REZONING STAFF REPORT

Case No. and Project Name: RZ-22-13-4, Mount Dora Groves South

Requested Action: Rezone approximately 80.32 +/- acres from Agriculture (A) and Urban Residential District (R-6), and establish a Planned Unit Development (PUD) to accommodate a mixed-use development including 783 single-family and multi-family attached and detached dwelling units, 150,000 square-feet of commercial uses, and associated recreational facilities

Attachment “E” – City of Mount Dora Comment Letter (Page 1 of 3)

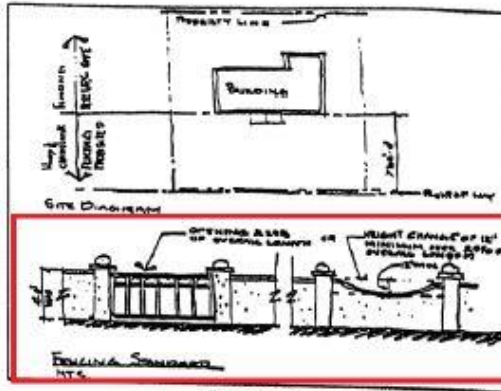
1. Trail surface material to be either asphalt or concrete (gravel is unacceptable material).
2. As stated in City's previous review pre-cast wall systems are not a design standard in keeping with the high quality expected for developments within Mount Dora. Illustration #15 of Section 6.13 of the City's Land Development Code (wall example next page).

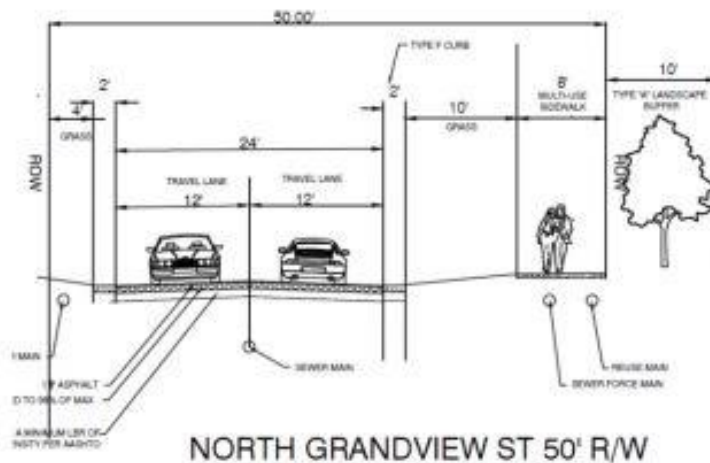
- 12. The configuration of the intersection improvements necessary for the Limit Avenue and Grandview Street intersection are lacking from the plans. Any proposed improvements require City review and input to assess any potential impacts to the City's planned facilities located on Limit Avenue (Alt Key No. 3916155).**

Response: The Developer included the following note on the attached Exhibit "B" plan:

THE GRANDVIEW EXTENSION ON SITE WILL CONTINUE THE 8' MULTI-USE SIDEWALK AND WILL INCLUDE A TYPE A 10' BUFFER ALONG THE EASTERN BOUNDARY. THE EASTERN BOUNDARY OF THE EXTENSION WILL INCLUDE A PRECAST CONCRETE WALL THAT WILL BE APPROVED AND CONSTRUCTED WITH THE ADJACENT RESIDENTIAL COMMUNITY. SIMILAR TO DORA LANDINGS, THE EXTENSION WILL INCLUDE 6' BENCHES WITH COORDINATING TRASH RECEPTACLES AT 500 FT INTERVALS AND DARK-SKY APPROVED FIXTURE AND LIGHT POLES. BELOW IS THE CROSS SECTION OF N. GRANDVIEW ST.

We also understand that the recently approved West Subdivision (Plat Book 76, Page 6) located on Limit Ave and Grandview Street (which is situated between our property and Dora Landings) was not required to reserve or construct any such multi-use trail.

EXHIBIT "B" DORA GROVES SOUTH PROJECT PUD PLAN

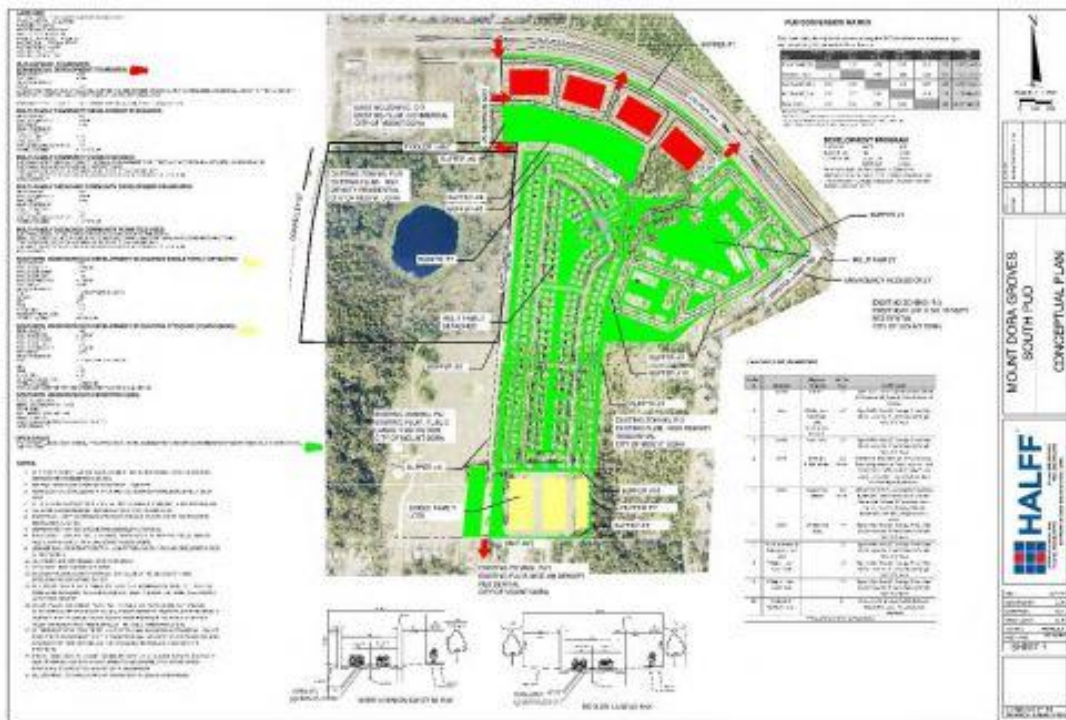
16. Public roadway connection from existing Bristol Lakes Road to planning Fiddler Drive extension required (Section 6.3 City LDC).

As shown on the Dora Groves South Project PUD Plan attached hereto as Exhibit “B”, the Developer has agreed to build a Precast concrete wall on the west side of the Grandview St. extension and Fiddler Drive extension, which equates to approximately 4,000 linear feet of wall or ¼ of a mile.

Response: Bristol Lakes Road is a private drive, not a public roadway. The following note has been included on our Dora Groves South Project PUD Plan and was noted in our Prior Detail Responses.
